**SUBJECT: BRUNSWICK STEAM ELECTRIC PLANT, UNITS 1 AND 2 – ISSUANCE
OF AMENDMENT REGARDING CORE FLOW OPERATING RANGE
EXPANSION (MELLLA+) (EPID L-2016-LLA-0009)**

The amendments approve a revision to the BSEP Technical Specifications to allow plant operation from the currently licensed Maximum Extended Load Line Limit Analysis (MELLLA) domain to operation in the expanded MELLLA+ domain under the previously approved Extended Power Uprate conditions, including a 2923 megawatt thermal rated core thermal power. The proposed request would expand the operating boundary without changing the maximum licensed core power and maximum licensed core flow.

1. Amendment No. 285 to DPR-71
2. Amendment No. 313 to DPR-62
3. Non-Proprietary Safety Evaluation
4. Proprietary Safety Evaluation

Figure 3.1.7-1 (page 1 of 1)
Sodium Pentaborate Solution Volume
Versus Concentration Requirements

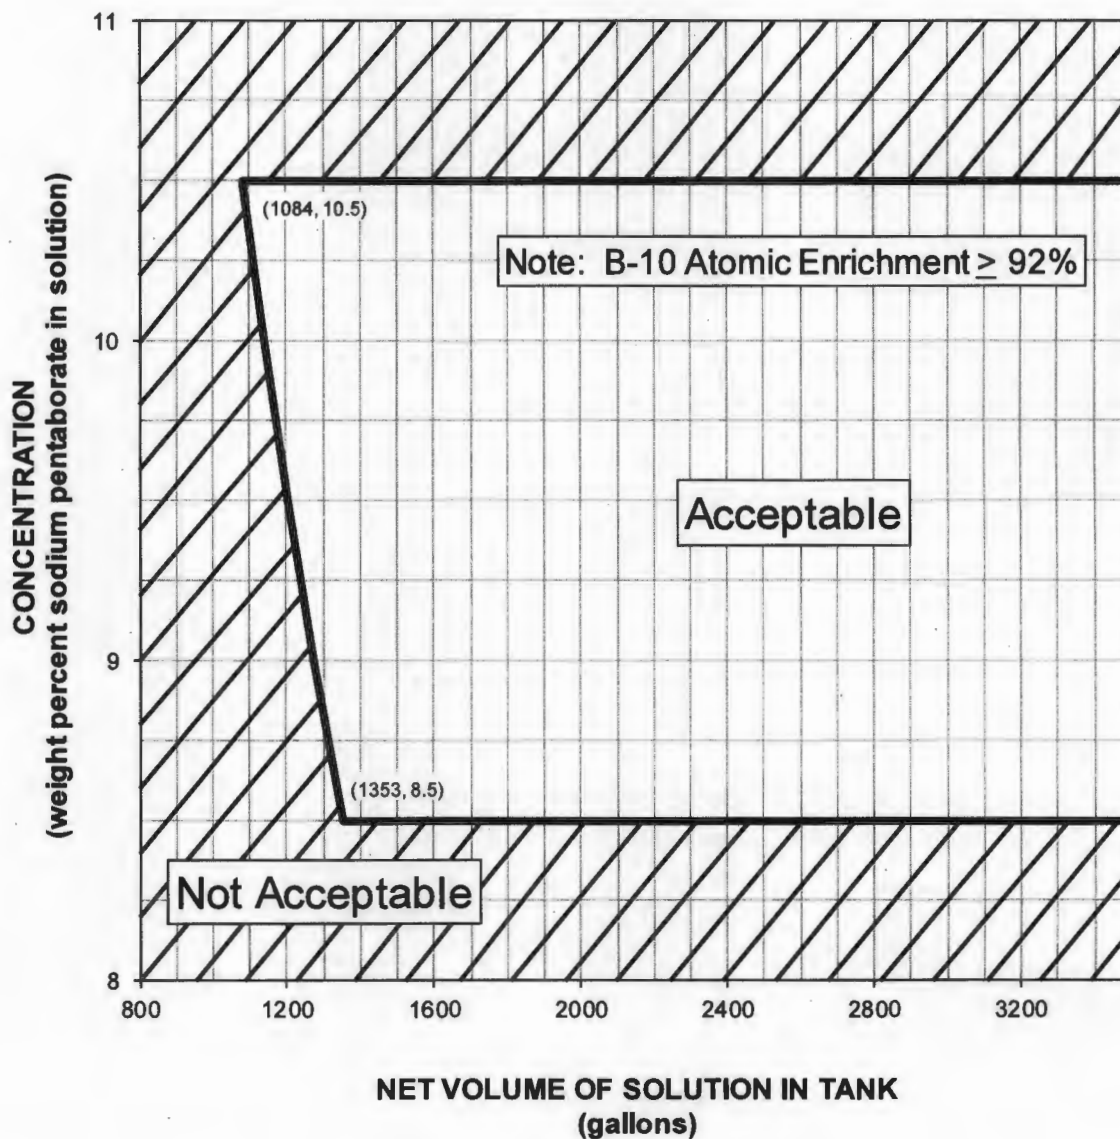
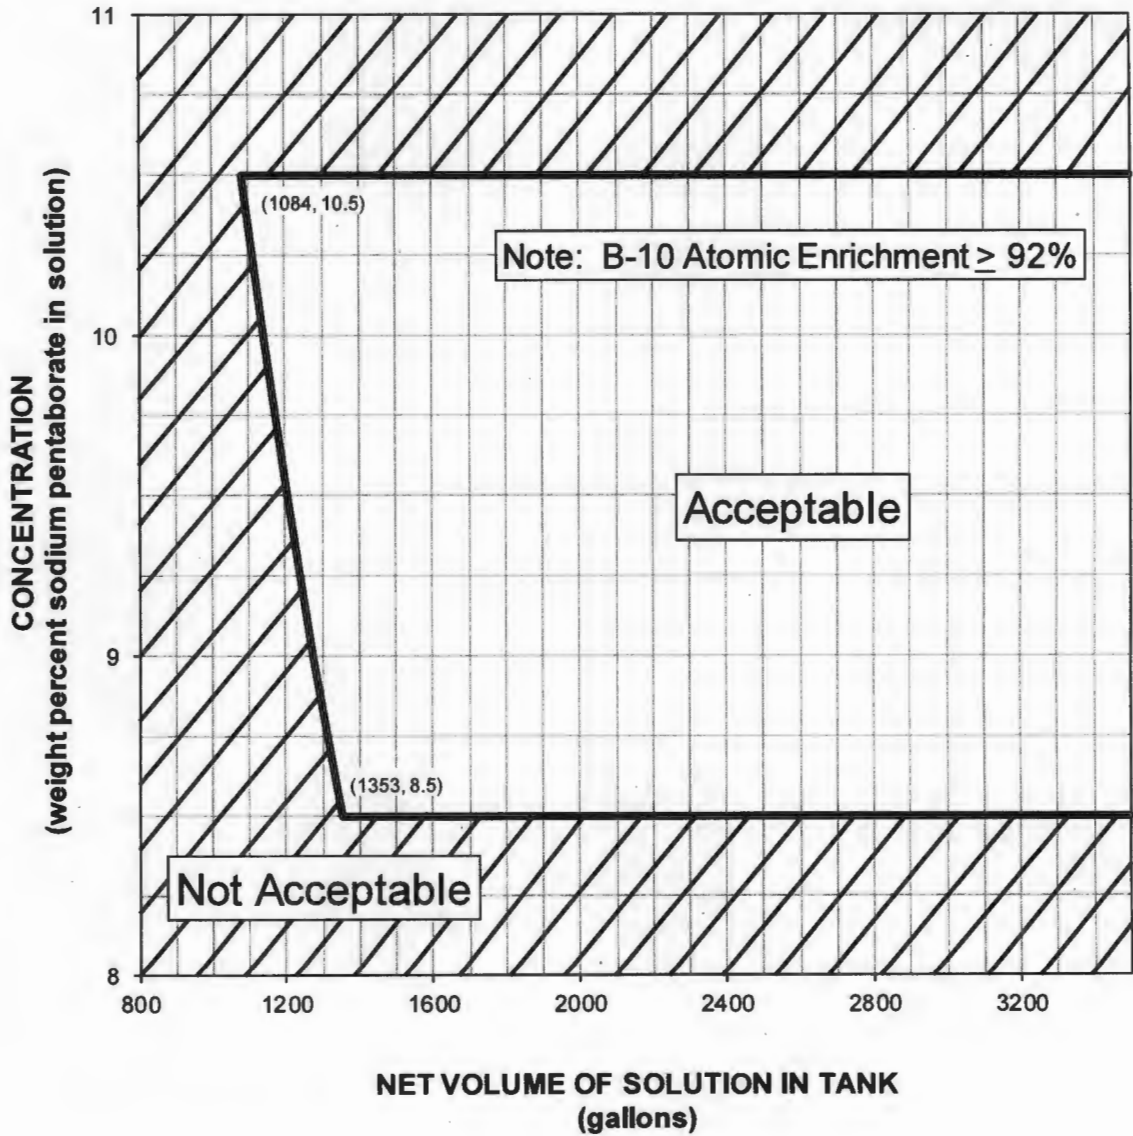
The licensee requested that TS 3.1.7 be revised to increase the minimum Boron-10 enrichment from ≥ 47 to ≥ 92 atom percent in this LAR, consistent with the increased enrichment assumed in its safety analysis. Both the licensing bases and the best-estimate ATWS calculations, based on this increased Boron-10 enrichment, show that the generic HSBW is effective to shut down the BSEP core under MELLLA+ initial conditions.

Change sodium pentaborate B-10 enrichment from ≥ 47 atom percent to ≥ 92 atom percent in SR 3.1.7.8 and Figure 3.1.7-1:

Figure 3.1-1 - Power/Flow Operating Map for BSEP MELLLA+

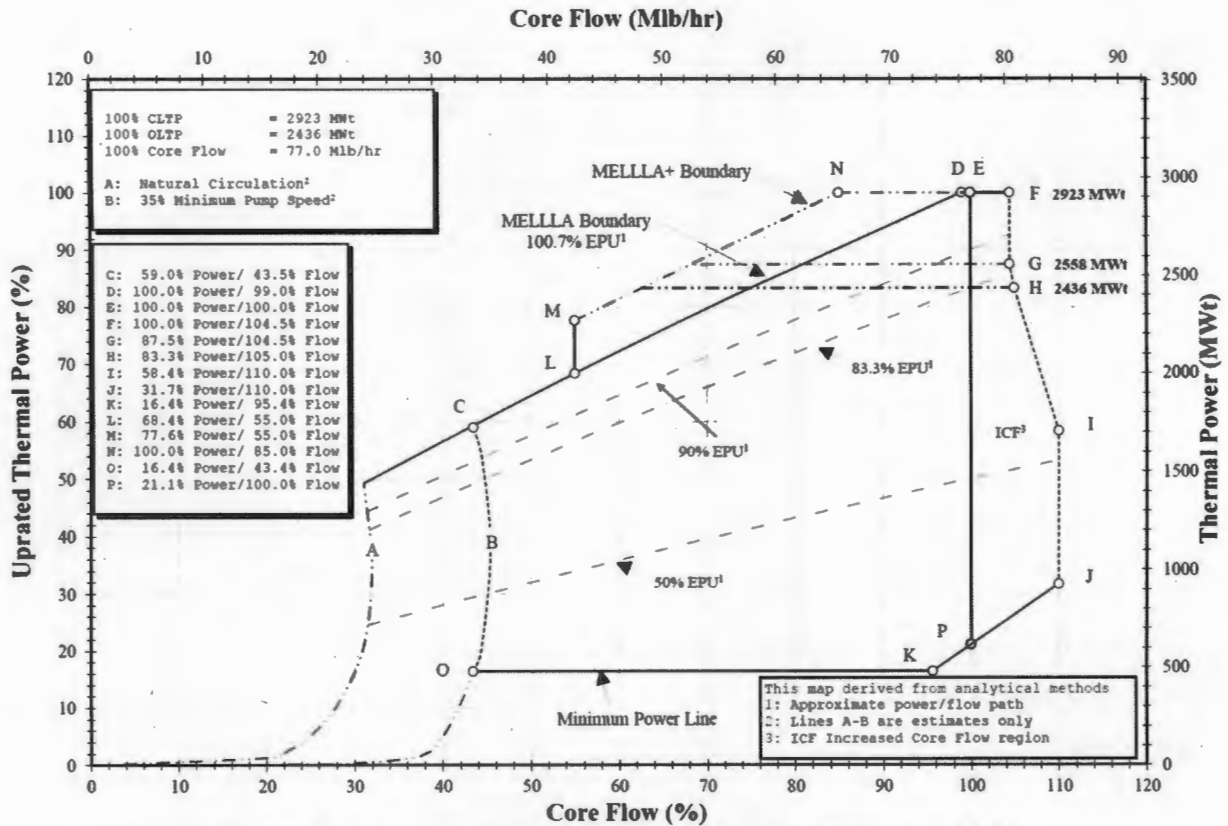
Figure 1-1 of the SAR (reproduced here as Figure 3.1-1) defines the MELLLA+ operating domain for BSEP. The upper boundary of the MELLLA+ domain is defined by the following relation between the percent core power (P), and the percent core flow (WT).

Table 4.2 of ANP-3280P provides a summary of the SLMCPR calculations performed for BSEP Unit 1 Cycle 19 for MELLLA+. The conditions evaluated are statepoints F (100%CLTP/104.5%Flow), N (100%CLTP/85%Flow), and M (maximum allowed power at 55.0%Flow) of Figure 3.1-1, which bracket the operating flow conditions at high power.

The licensee stated that this limitation is applicable. Only the low flow/high power point in the MELLLA+ domain (point M in Figure 3.1-1) exceeds 50 MWt/Mlbm/hr (with a value of 53.55 MWt/Mlbm/hr). However, the licensee stated that this point is not used for extended periods of operation, and that this limitation is not intended to place operation restrictions on the plant (Reference 6). Furthermore, the licensee stated that the requirement to provide power distribution assessment for plants exceeding 50 MWt/Mlbm/hr does not apply to AREVA methods, as the use of AREVA methodology at BSEP, including the applicability of power distribution uncertainties, is addressed in ANP-3108P (Enclosure 12, Reference 1). The NRC staff reviewed ANP-3108P and requested additional information that justified the AREVA methods at low flow/high point in the MELLLA+ domain of not including an additional SLMCPR penalty (described in Limitation 9.5 below) in SRXB-RAI-12.

Figure 3.9.3.3-2: Case 1 – Peak Cladding Temperature

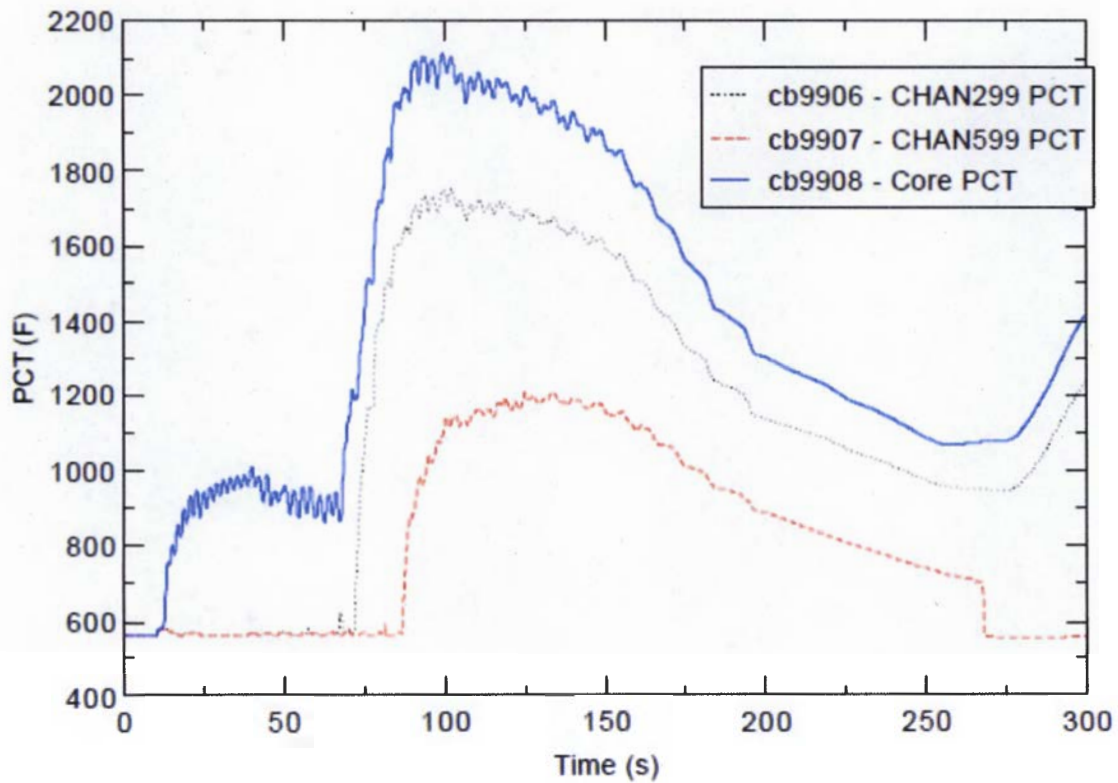
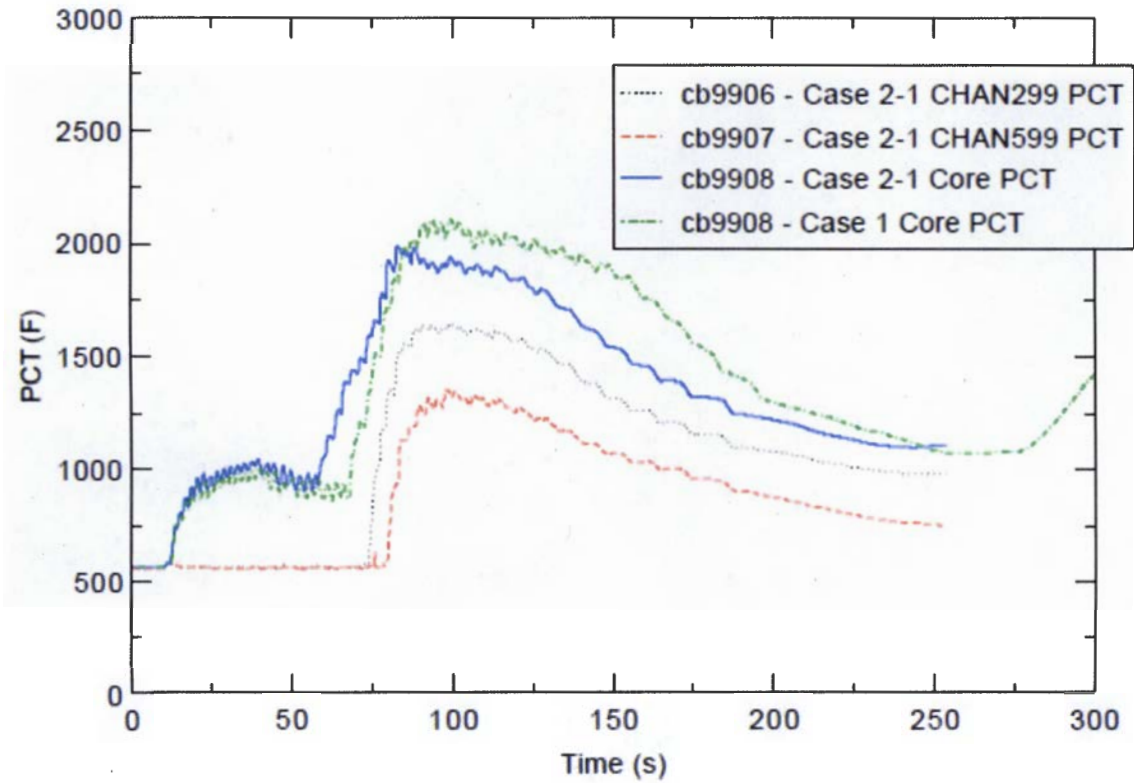
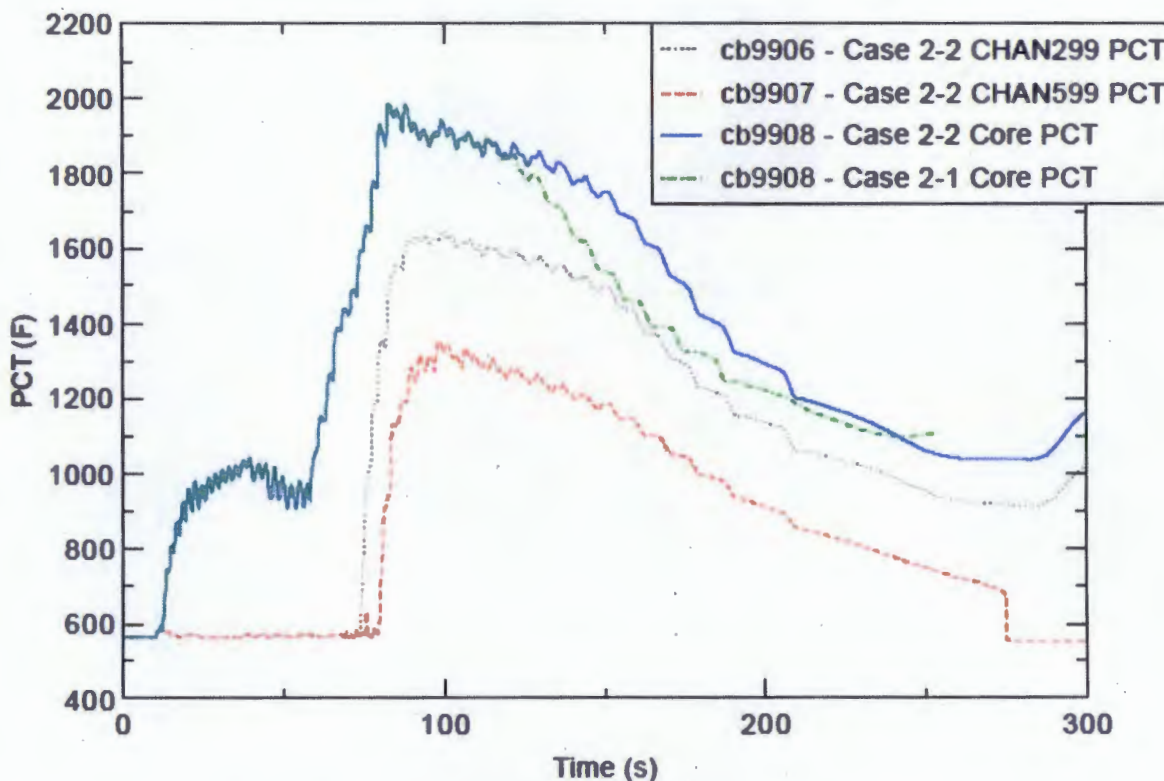
The TRACE/PARCS calculations indicate that there is no fuel damage in Case 1 with a PCT of 2109 °F. As seen in Figure 3.9.3.3-2, the PCT increases early in the transient in response to the depressurization and 2RPT. This is a result of dryout followed by a mild fuel heat-up. PCT remains close to 900 °F until the onset of large amplitude power oscillations after 50 sec. The core PCT and CHAN-299 PCT responses show significant heat-up around the same time (~70 sec). Core PCT reaches ~2100 °F around 100 sec. Core PCT and candidate assembly PCTs begin to drop subsequently as manual operator actions begin to take effect and reduce core power and oscillation amplitude.

Figure 3.9.3.3-3 shows the PCT for the core and candidate hot assemblies for Case 2-1. For reference, the core PCT from Case 1 is also shown. While there are some differences that lead to an earlier rise in core PCT in Case 2-1 around 60 sec, the Case 2-1 PCT is ultimately lower. The differences in the calculations include the different FW temperature transient and the assumed gap conductance, a combination of these two effects would explain the difference in the initial PCT rise. The core PCT in Case 1 continues to increase through 100 sec and remains higher longer compared to Case 2-1. The effectiveness of level reduction in Case 2-1

Figure 3.9.3.3-4 compares the Case 2-2 and Case 2-1 PCT responses. Because the heat transfer coefficient of the gap between the fuel pellet and cladding (HGAP) and FW temperature ramps are the same in Case 2-1 and Case 2-2, the responses are identical prior to manual action to control level. Major trends are consistent in Case 2-2 with Case 2-1 except that the FW flow drops later, resulting in later level reduction and later FW flow restoration. A comparison of Case 2-2 with results provided in the response to RAI SRXB-7 indicate relatively good agreement in plant parameters as well as PCT. The TRACE predicted result is 1988 °F compared to [] in provided by the licensee. The TRACE result can be expected to be higher due to the early dryout leading to higher PCT in the TRACE calculation compared to TRACG. Therefore, a more reasonable basis for comparison is the CHAN-299 response, which is a hot assembly that does not undergo the early dryout shown in the Core PCT response. The CHAN-299 PCT is 1646 °F. This value is an underestimate because the CHAN-299 signal is based on an average powered rod instead of a hot rod. Therefore, removing the early dryout effect means that the PCT would be between 1646 °F and 1988 °F, which compares well with the TRACG result of []. These results are in closer agreement because they are not as sensitive to the difference in instability onset timing since the operator action to lower level occurs after heat-up in both cases.
